TEXAS UTILITIES SERVICES INC.

TX-3500

April 8, 1982

SUBJECT: COMANCHE PEAK STEAM ELECTRIC STATION
FIRE BARRIER DERATING

The Fire Barriers in question are shown on the enclosed drawing, FHA-19, and the affected fire areas described below:

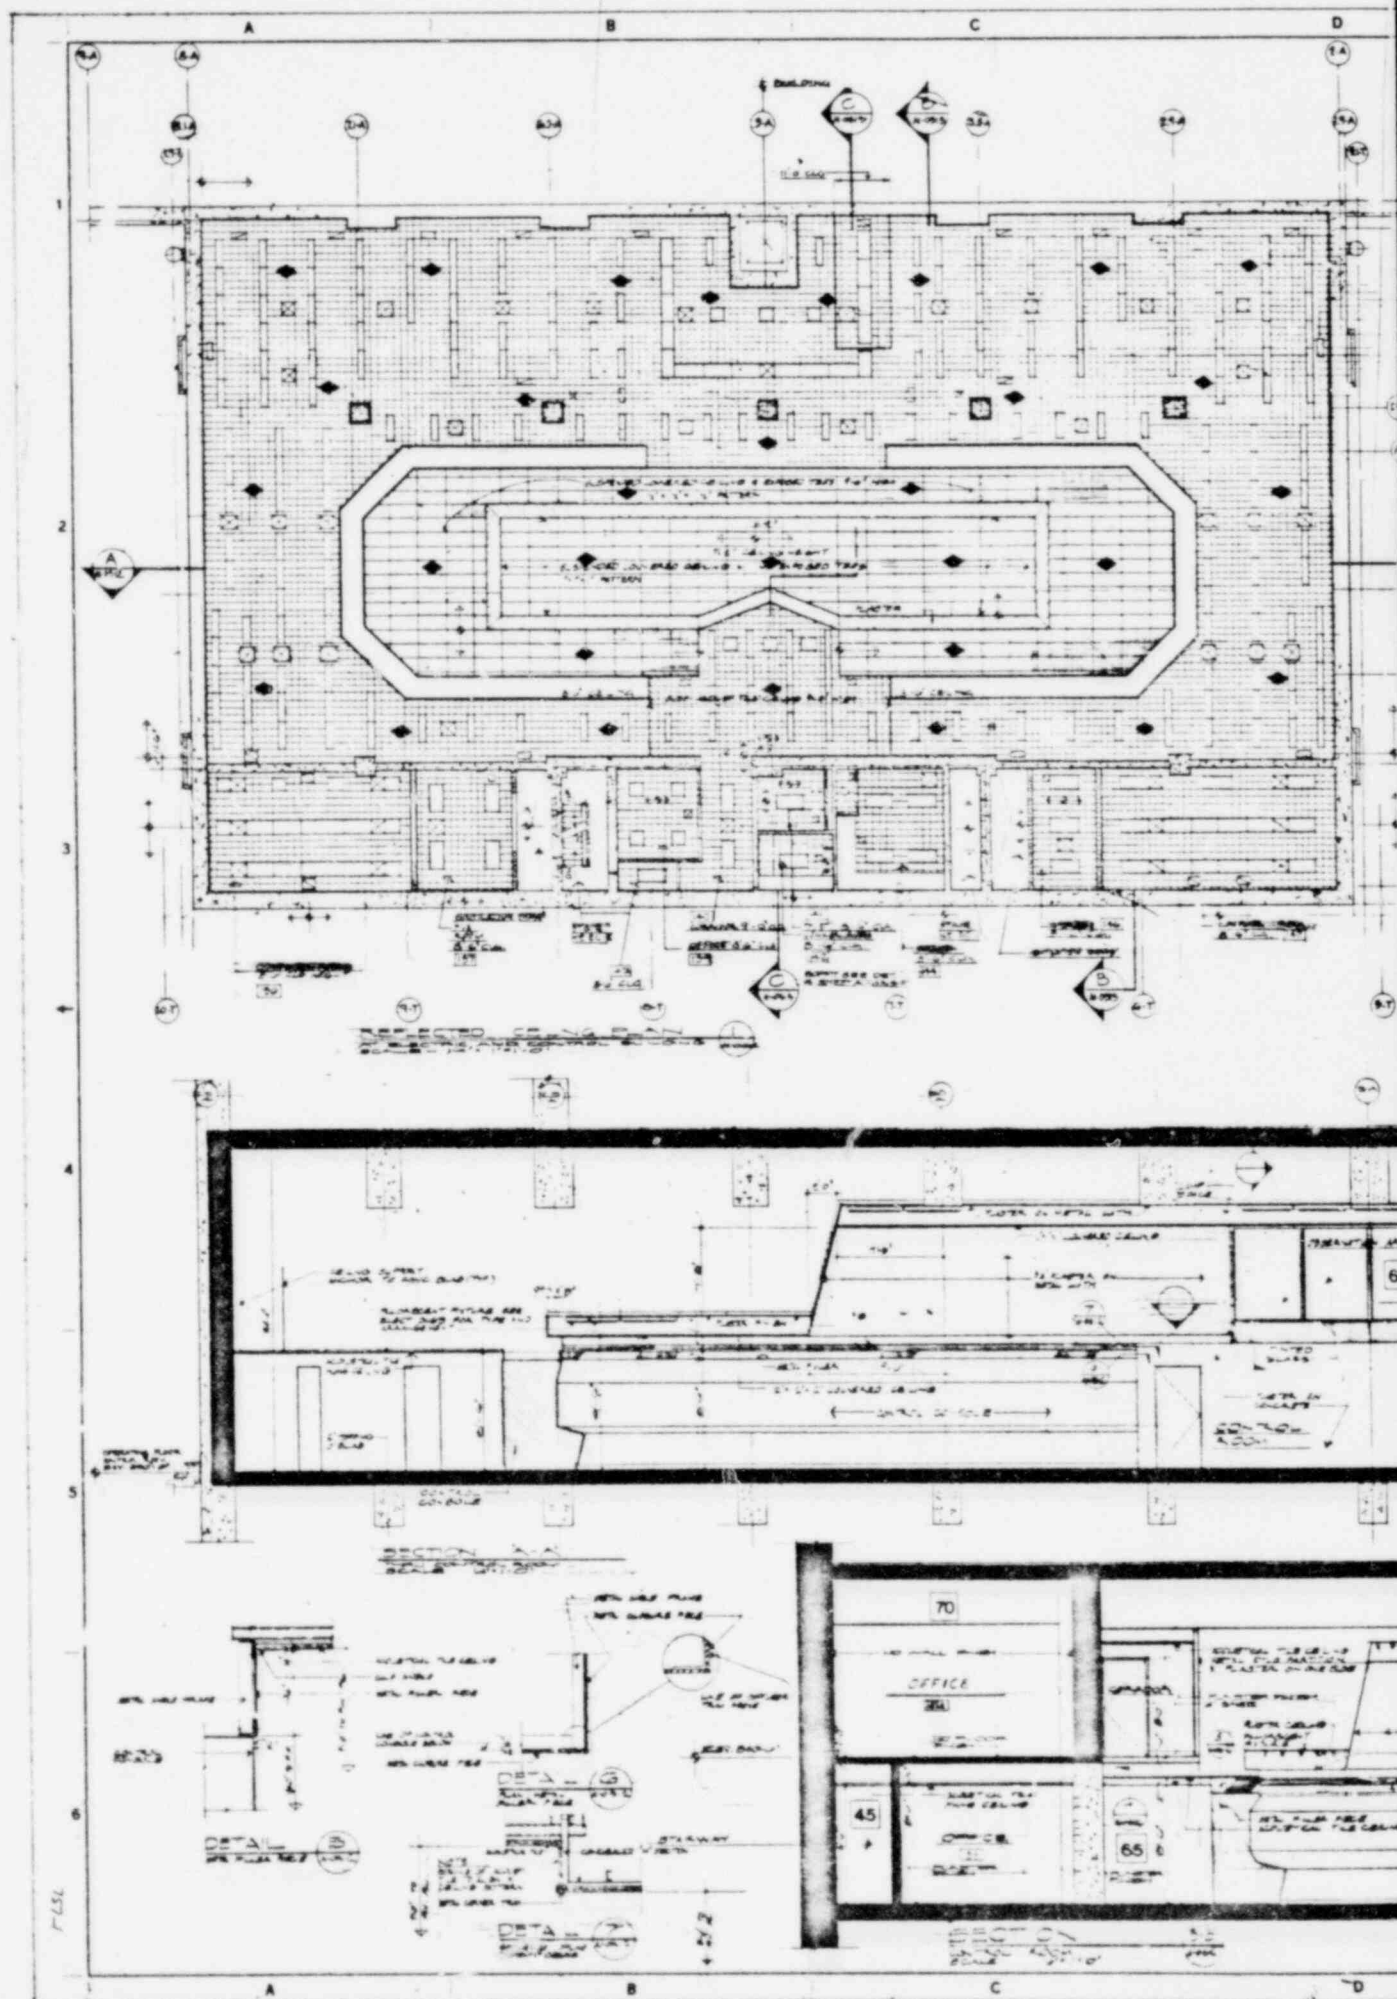
Portions of the Fire Barriers which make up the boundaries of fire Areas 65, 71, 72, 140 and 141, do not meet the ASTM E119 requirements for a three hour fire rating. However, the design has been accepted by the ANI as being three hour equivalent.

The barriers are constructed of UL listed gypsum board 5/8" thick built three layers deep on each side of metal studs. The joints are staggered for each layer and sealed. This construction meets and exceeds the requirements of two hour rated barriers. It is proposed that the barriers separating these fire areas be derated to two hour barriers in lieu of the three hour rating that is currently required. This derating will permit our design to remain as currently installed, and still maintain a satisfactory level of protection.

FIRE WALL SECT.

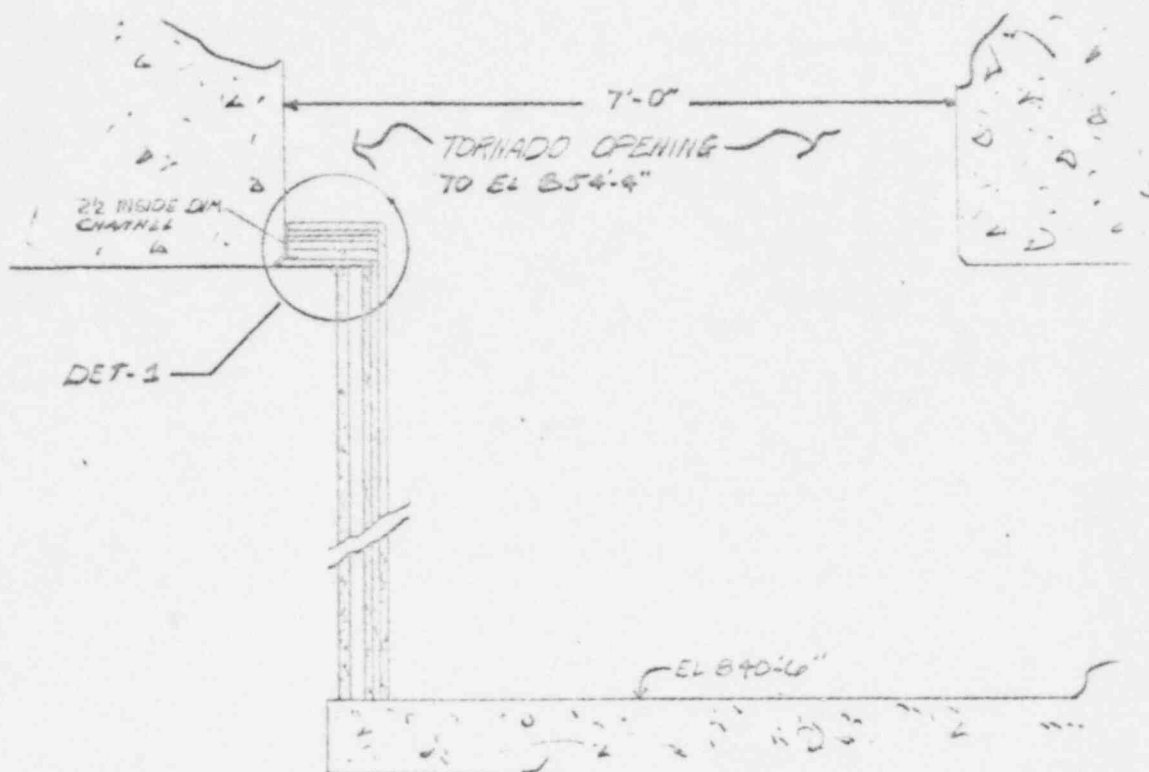
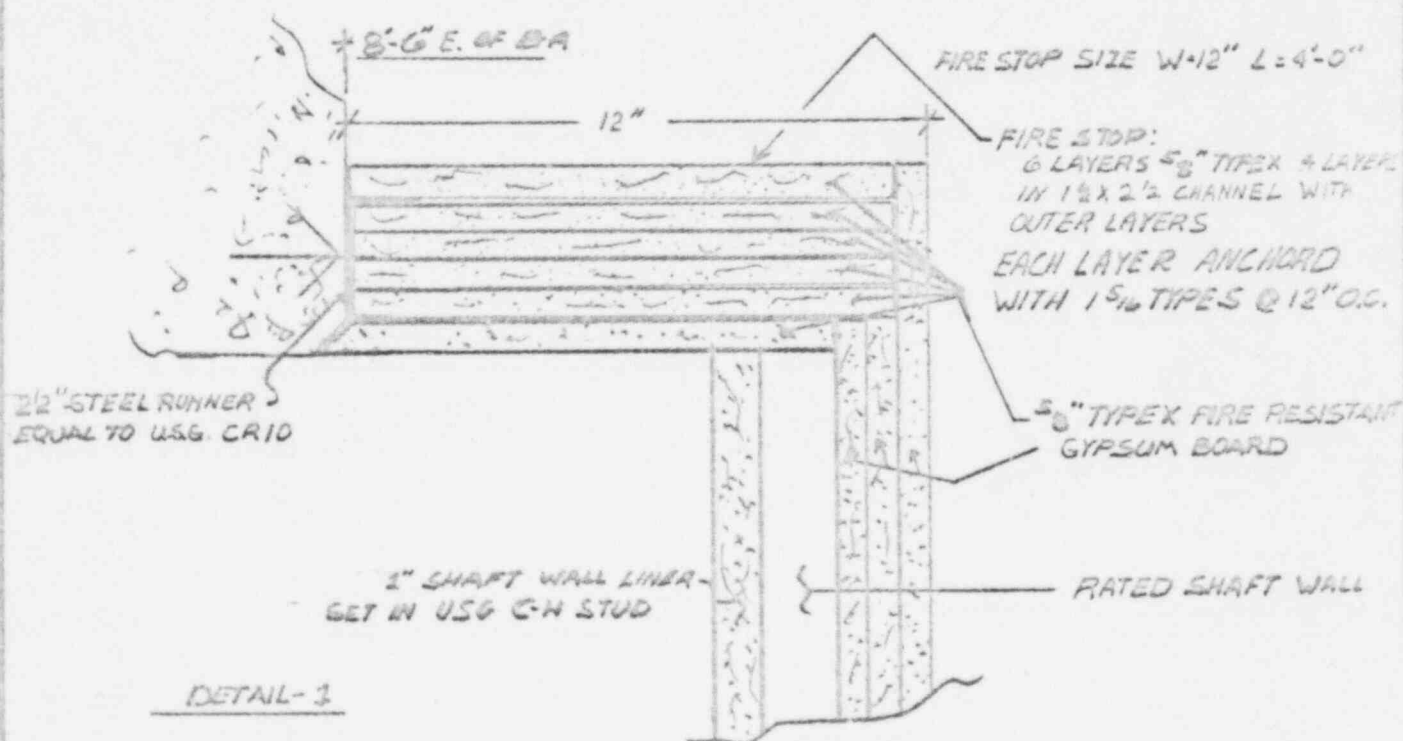
In a related issue, a portion of the fire barrier separating the mezzanine areas (Fire Areas 140, 141) from the Control Room (Fire Area 65) at elevation 840'-6", does not use a design that has been approved as a three hour fire barrier (see attached Brown and Root drawing). The 10th edition of the Gypsum Association Fire Resistance Design Manual, rates a multi-layer gypsum board 2 inches thick as a two hour fire barrier. In the subject area the CPSES design utilizes 3 3/4 inch thick multi-layer, type X gypsum board. Although this design has not been verified by fire test, we believe that it meets or exceeds the required three hour fire rating.
